5
		B0200003

SB, Upgrading cutting disc and skid plate from 1998 to 2002 specification, 2002-01

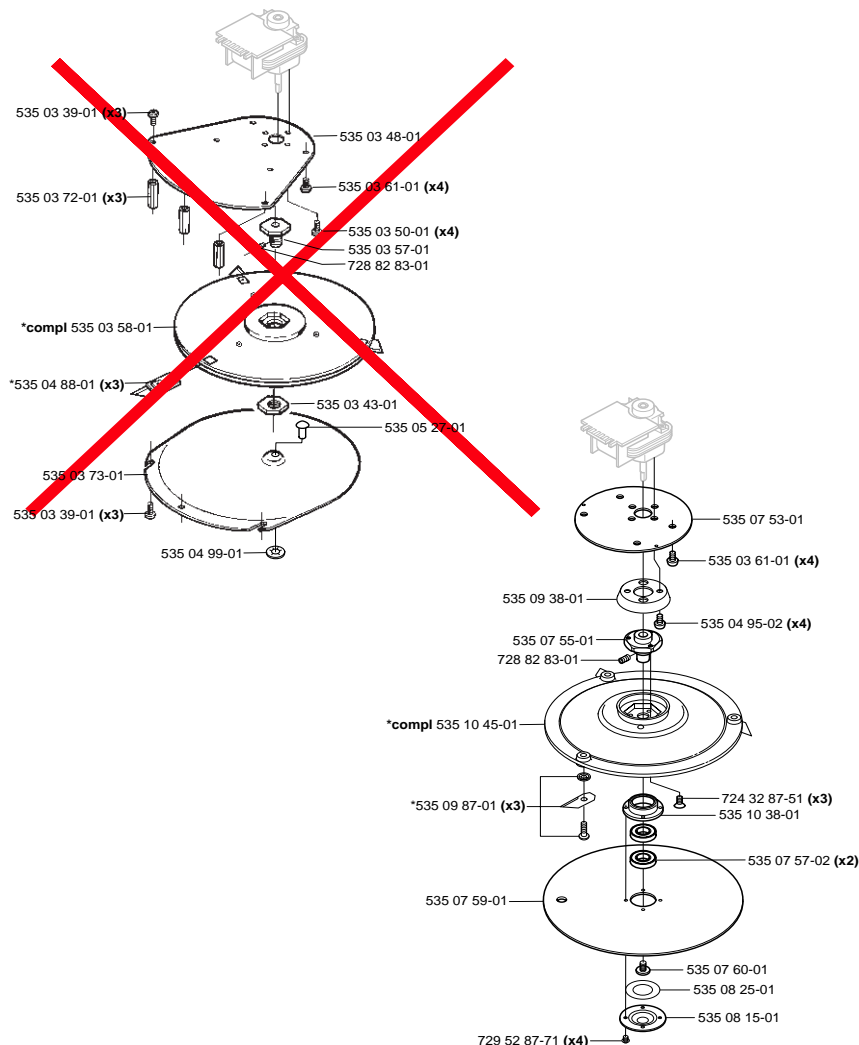
Kit 535 10 27-01 contains all the necessary parts to convert the cutting disc and skid plate on a 1998 model Auto Mower or Solar Mower to 2002 specification. The main advantages of the new skid plate and cutting disc are as follows:

- Less risk of grass or foreign objects becoming trapped between the cutting disc and skid plate, or around the cutting motor shaft.
- The single cutting disc maintains its balance better, since less grass and soil, etc., gets trapped inside the disc. Reduced vibration means that the mower as a whole and the cutting motor in particular have a considerably longer life.
- The new type of blade, designed for the single disc, is considerably cheaper than the old type used on the double disc. This means that the cost of the upgrade to the consumer will be paid back relatively quickly.
